United States Department of the Interior

FISH AND WILDLIFE SERVICE

July 11, 1984

This responds to your letter of June 18, 1984, requesting information on Federally listed threatened and endangered species that may be affected by the Vogtle Electric Generating Station in Burke County, Georgia and its associated transmission corridors.

Figure 1. Red-cockaded Woodpecker colonies in Georgia: 1966-1980.

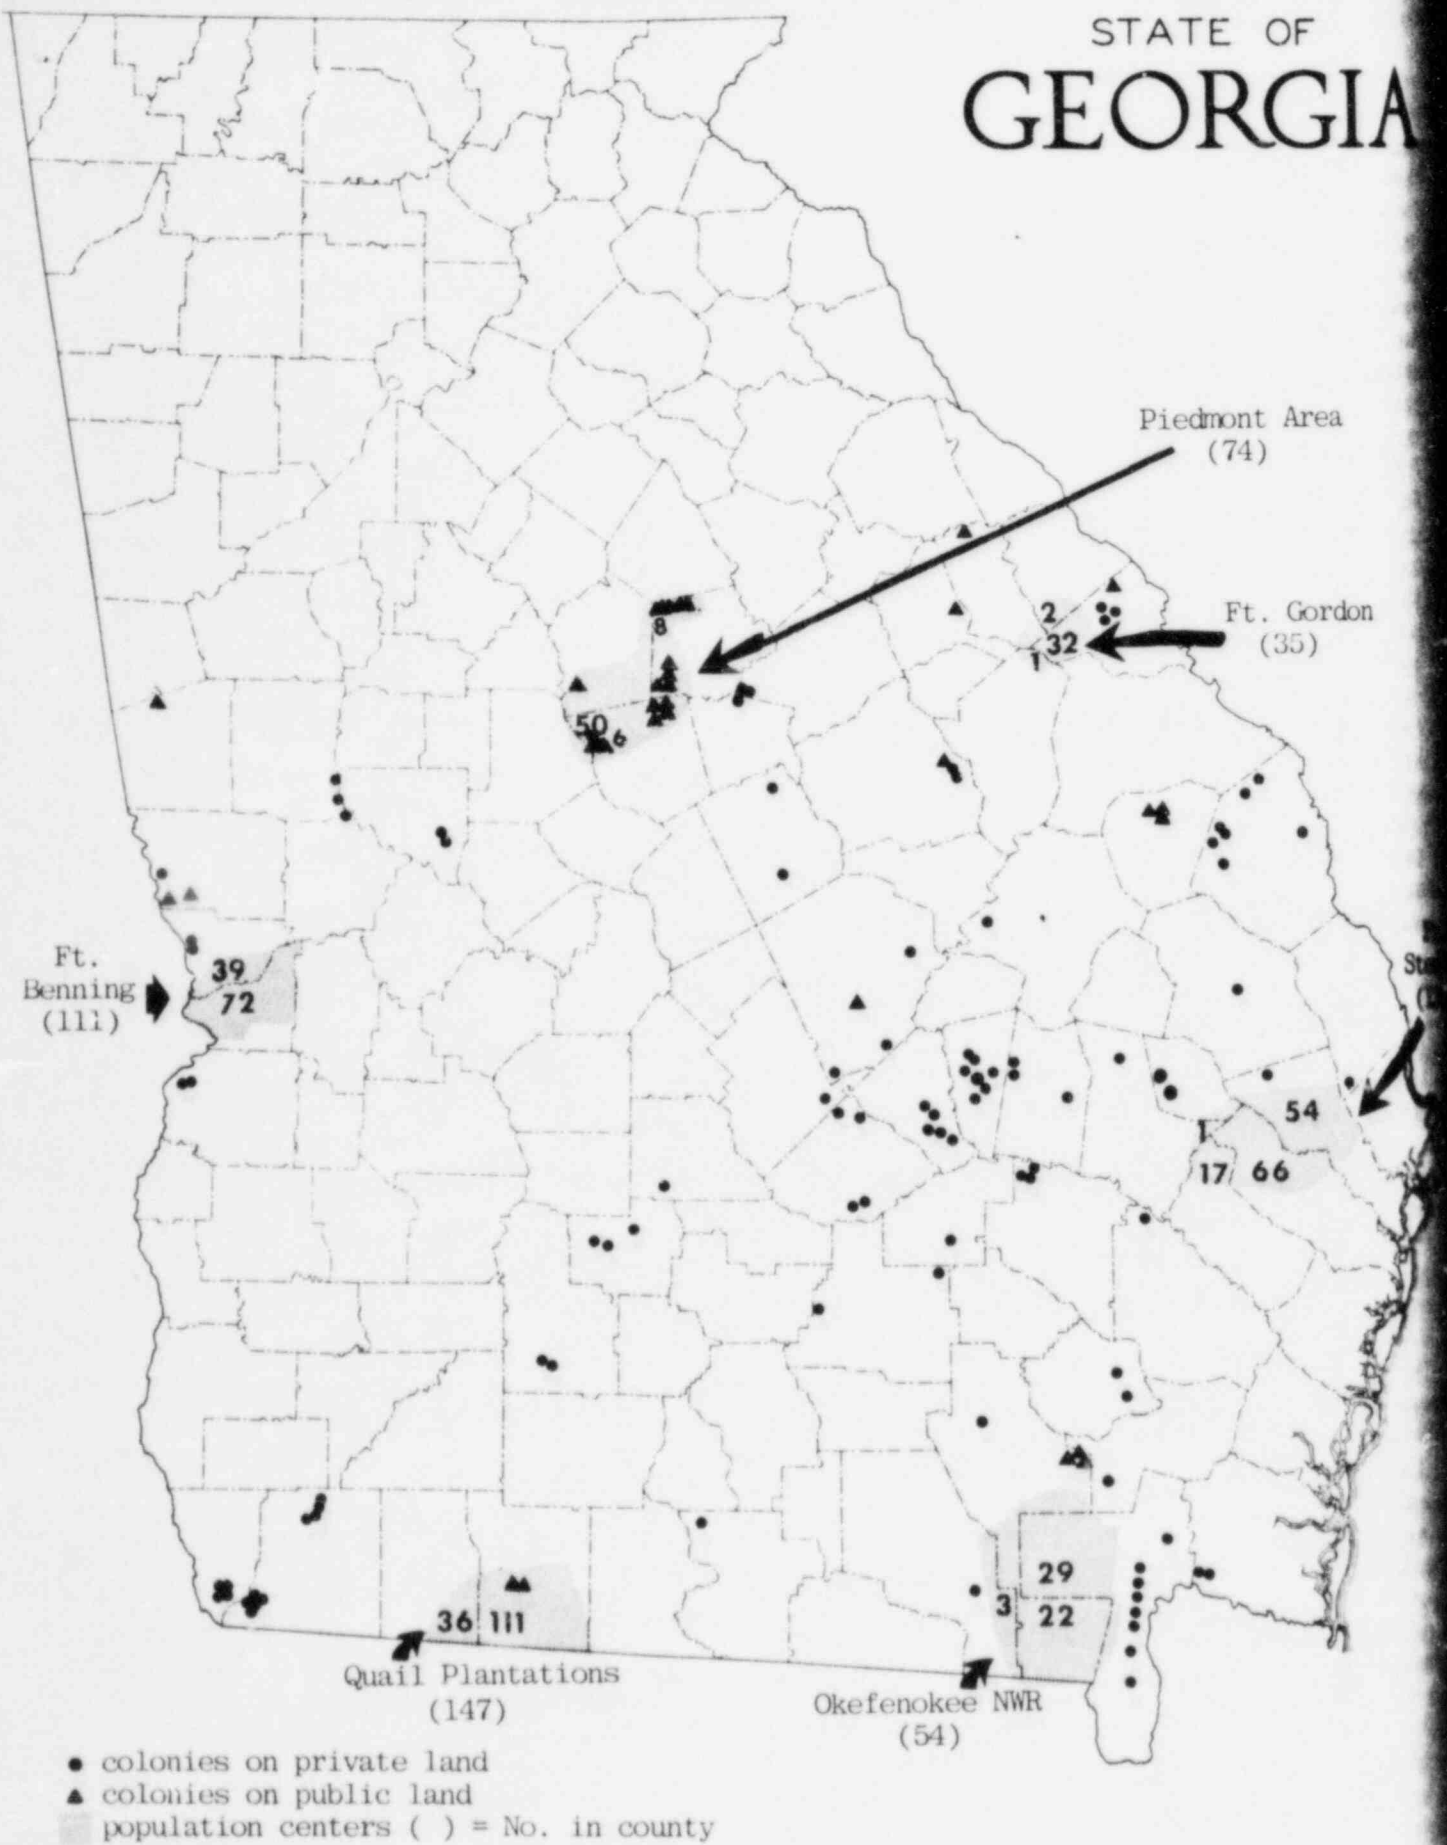
We suggest that during the evaluation of the transmission line corridor, the status of the red-cockaded woodpecker be determined. We have enclosed a map showing the known colony sites, however, others may exist in this area.
